I refer to Council's submission on the Preferred Infrastructure Report (PIR) and Submissions Report on the CBD and South East Light Rail (CSELR) project forwarded to Planning and Infrastructure on 28 March 2014.

I refer to Council's submission on the Preferred Infrastructure Report (PIR) and Submissions Report on the CBD and South East Light Rail (CSELR) project forwarded to Planning and Infrastructure on 28 March 2014.

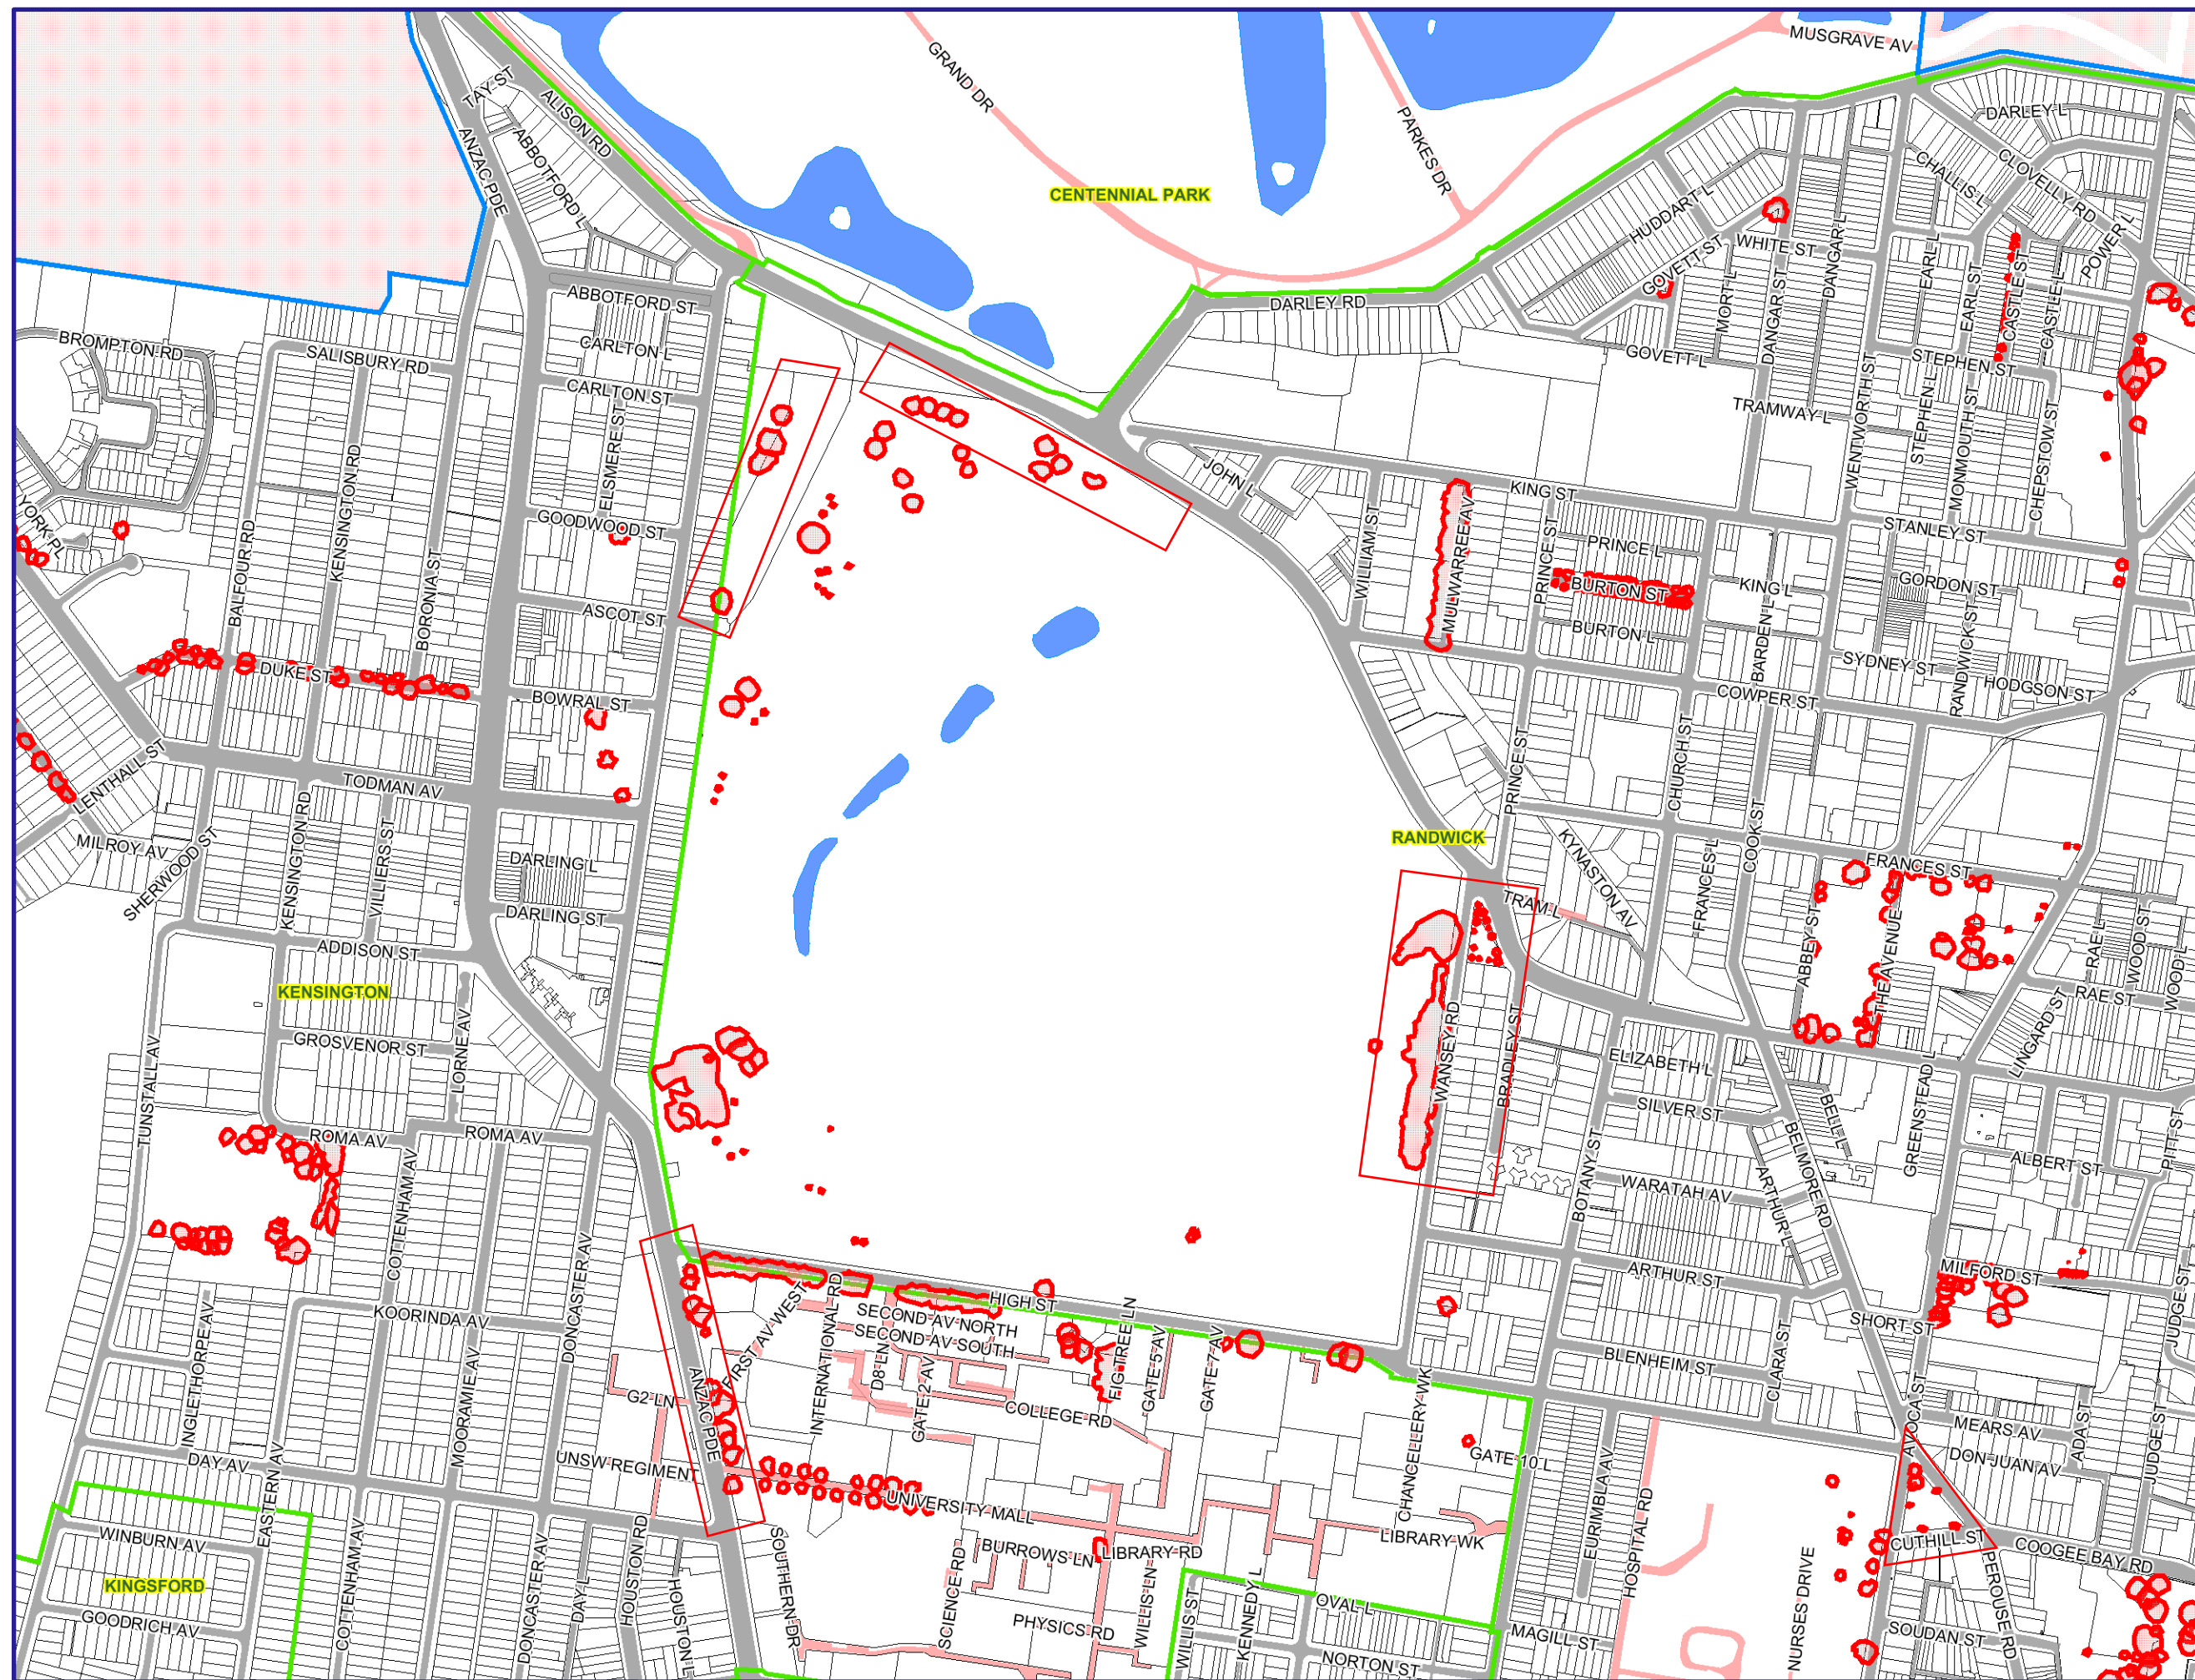
A copy of a plan illustrating the location of the significant trees affected by the CSELR project and a further plan focussing on Wansey Road are attached for your information. These plans will assist in highlighting concerns outlined in this letter.

Further to Council's submission, I would like to emphasise specific concerns raised in the submission, in particular the impact of the proposal on identified significant trees on Randwick Racecourse land generally and specifically those adjoining Wansey Road. Council's submission puts forward an option of distancing the light rail vehicles and catenary from the significant trees by means of locating the shared pedestrian cycle path on Wansey Road along the edge of the Randwick Racecourse land. The drawings in the PIR are illustrative in nature and do not plot the property boundary, however given the spaces involved it can be estimated that the light rail catenary will impact on the trees and require the removal of boughs and likely a large number of trees. This impact can be reduced by the minor design modification suggested by Council.

The proposed mitigation measures contained Submissions Report are also of concern in this regard. Your attention is drawn to No.C.1 on page 8-5 which refers to recreating the lost tree canopy on Wansey Road, as if their removal is a fait accompli. The mitigation measure should focus on their protection rather than assume their removal.

The significant trees identified in the attached plans are worthy of some additional designed refinement to ensure their protection. Their landscape and environmental values are such that Council requests a clear role during the detailed design and construction phase to ensure their protection.
